# SERVICE BULLETIN

Number: SRE10-02  
Section: Recall  
Date: 23 NOV 2010  
Model: LR2

Subject: Safety Recall P116 (NHTSA # 10V581)

### Safety Recall: Airbag Clockspring Connector

Figure 1

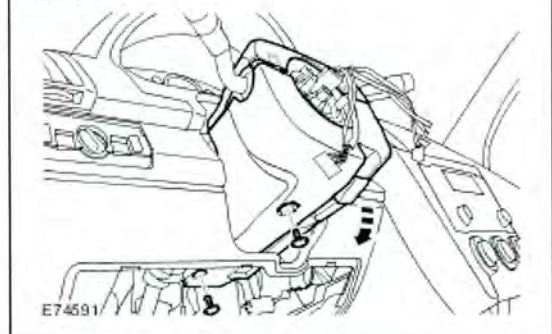
2. Release the steering column lower cowl. (Figure 1)
  - Release the steering column adjustment lever.
  - Remove the two Torx bolts.
3. Disconnect the electrical connector. (Figure 2)
4. Install the clockspring electrical connector spacer.
  - If this spacer is already installed, do not remove the existing or install another spacer; continue to step 5.
5. Connect the electrical connector.
6. Install the steering column lower cowl: (Figure 1)
  - Tighten the two Torx bolts to **3Nm (2.2lbf ft)**.
  - Tighten the steering column adjustment lever.
7. Connect the positive battery cable.
8. Connect the negative battery cable.
